International Isotopes Inc.

Subject: Submittal of Responses to Requests for Additional Information (RAI)
TAC L32739.

The following document is provided as a response to the US Nuclear Regulatory Commission RAIs pertaining to the International Isotopes Fluorine Products Inc. December 30, 2009 application to license a depleted uranium hexafluoride de-conversion and fluorine extraction process facility.

(1) Organization & Administration

Figure 2-1 IIFP Project Design and Construction Organization

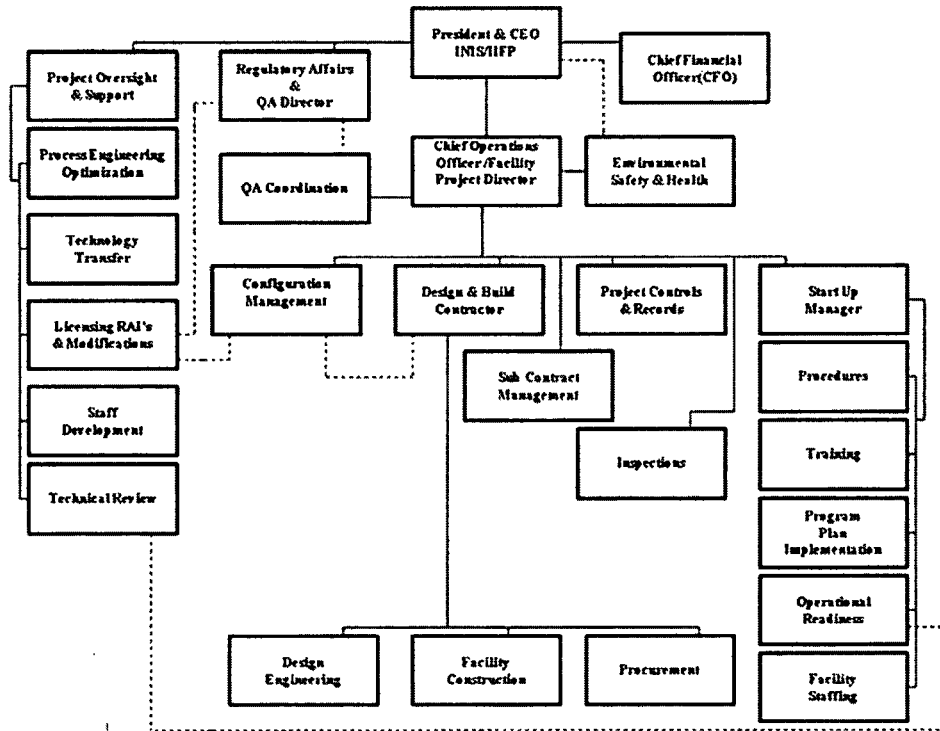
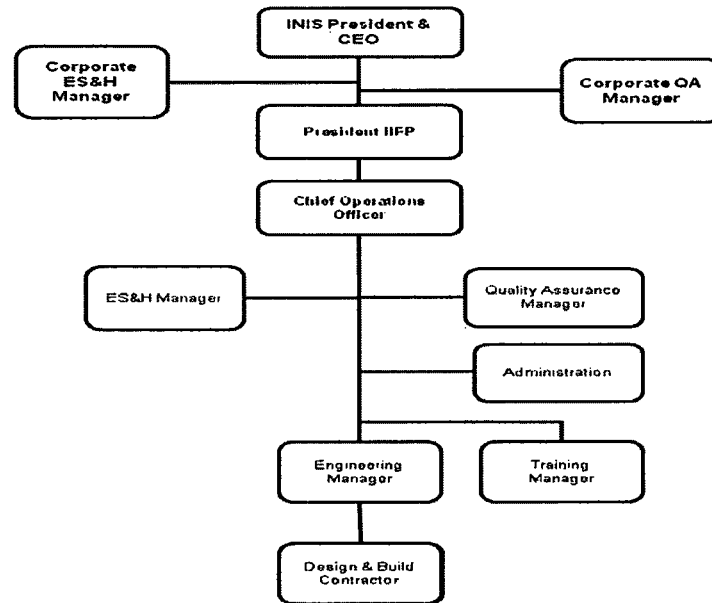
OA-7. *The organizational structures displayed in LA Figures 2-1 and 2-2 have a complex interconnectivity (“matrix structure”) which is not well defined in LA Sections 2.1.2 and 2.1.4. Consistent with NUREG-1520, Sections 2.4.3(1) and 2.4.3(2), provide the following information:*

A. *To demonstrate a clear, unambiguous set of management controls and communications among organizational units, reduce the complexity of LA Figures 2-1 and 2-2 or expand the explanations in 2.1.2 and 2.1.4, or both. This may involve reducing the level of detail in the figures, focusing the explanation in the text to explain the groups responsible for the “design, construction, and operation of the facility [NUREG-1520, 2.4.3(1)],” removing or explaining dual reporting relationships, making the Figures layouts easier to read, etc. Any dual reporting listed in the Figures should be explained in the text.*

- C. *The application indicates that the COO has responsibility for the design, engineering, construction, startup, operation, maintenance, etc. However, the COO/Commercial Facility Project Director (CFPD) (Design/Build (DB) phase) is not at the top of the Figure 2-1; nor is the COO/Plant Manager (operations phase) at the top of Figure 2-2. In addition, several other groups are parallel or above the COO for both phases. Consistent with NUREG-1520 2.4.3(1), clearly indicate which individuals listed in LA Figures 2-1 and 2-2 are ultimately responsible for overseeing the design, construction and operation of the facility.*

RESPONSE: Section 2.1.2 discusses the design and construction organization and Figure 2-1 shows the design and construction organizational structure for that organization. Figure 2-1 has been revised to eliminate the matrix organization, particularly for the QA and ESH functions, to show both a Corporate ESH Manager and a Corporate QA Manager in the INIS parent corporate organization and also an IIFP ESH Manager and an IIFP QA Manager. When the IIFP positions of IIFP ESH and QA Managers are filled, any of the IIFP Facility ESH and QA responsibilities, duties and authorities that were temporarily being performed by INIS Corporate staff will transfer to the IIFP ESH and QA Managers. (identified in Revision A of the LA as the QA Coordinator) for the IIFP Facility. Also see RAI OA-7A.

RESPONSE: The matrix structure has been omitted from organizational charts (Figures 2-1 and 2-2) with the corresponding dual reporting text deleted in the LA Chapter 2 Revision B rewrite of Sections 2.1.2 and 2.1.4.

Revision A figure below is deleted and replaced with Figure 2-1 on following page

Figure 2-1 has been revised with the IIFP President at the top of the IIFP organization and the highest authority within IIFP. The IIFP President reports to the parent corporation INIS President/Chief Executive Officer. The other management individuals in the parent corporation that interrelate with the IIFP President are the Corporate ESH Manager and the Corporate QA Manager. These parent corporate staff managers interrelate with the IIFP President by assisting the IIFP COO and providing support to the IIFP ESH and QA management (See Section 2.2.2 of the IIFP LA Chapter 2 Revision B attached). The COO reports directly to the IIFP President and as such is delegated the line organization authority for the responsibility of managing the administration, ESH, QA, engineering, training and supporting contractor functions during the licensing, design and construction of the IIFP Facility. Once the IIFP Engineering Manager is hired the COO will assign responsibilities and delegate authority to the Engineering Manager, who reports to the COO, for providing design authority and direct oversight of the Design and Build Contractor and for ensuring professional and contractor support is in place to perform any required Integrated Safety Analysis and licensing documentation.

Figure 2-2 Plant Operation Organization

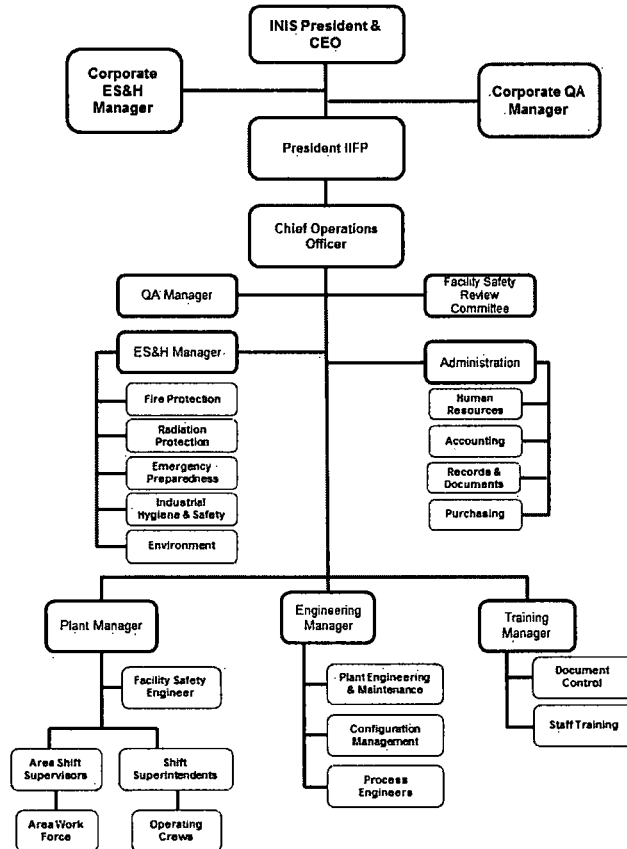
A. *The third paragraph on LA Page 2-6 indicates that the ESH and QA have authority and responsibility to contact the INIS President/CEO (rather than the IIFP President/CEO) directly, under certain circumstances. The INIS President/CEO position appears to be outside the organizational structure of the IIFP. Consistent with NUREG-1520, 2.4.3(1) and (2), revise the reporting requirements so that the ESH and QA report to an individual within the corporate structure.*

Section 2.1.4 indicates that the Chief Operations Officer (COO)/PM (Plant Manager) reports to the INIS President/CEO. This individual appears to be outside the IIFP corporate structure. Consistent with NUREG-1520, Section 2.4.3(2), revise the text in 2.1.4 to indicate that the COO/Plant Manager reports to the IIFP President/CEO.

- C. *LA Section 2.2.3 states that the Regulatory Affairs and Quality Assurance Director (RAQD) is appointed by the INIS President/CEO. This appears to indicate that the RAQD is an INIS employee and not an IIFP employee. The section also states that the RAQD is responsible for the ESH and QA policies. Consistent with NUREG-1520, Section 2.4.3(3), state in the LA that the RAQD is an IIFP employee. Clarify the reporting relationship and management structure between RAQD, COO/Plant Manager, Quality Assurance Coordinator (QAC), and ESH.*

- C. *The bulleted list in Section 2.1.4 on Pages 2-5 and 2-6 appears to match positions listed in LA Figure 2-2. Ensure that the management positions listed in Figure 2-2 match the positions contained in the bulleted list.*

RESPONSE: The organization is structured as a stand-alone organization with the IIFP President responsible for the entire organization and reporting to the parent corporation INIS Present/CEO shown as Figure 2-2. See RAI OA-7A for revised figure.

RESPONSE: The organizational chart for the Plant Operation Organization of the IIFP (Figure 2-2) has been revised to replace the position of the RAQD with both a Corporate QA Manager and a Corporate ESH Manager reporting to the INIS President and CEO. The responsibilities for these corporate positions are provided in Section 2.2.2.of the attached rewrite (Revision B) of the IIFP LA Chapter 2.

The revised Figure 2-2 shows the same organizational structure during the plant operations phase. A position of Plant Manager reporting to the COO was added to the Plant Operation Organization chart. The responsibilities for the Engineering Manager, the COO, the Plant Manager, and the IIFP President are delineated in Section 2.2, "Key Management Positions, Responsibilities, and Qualifications."
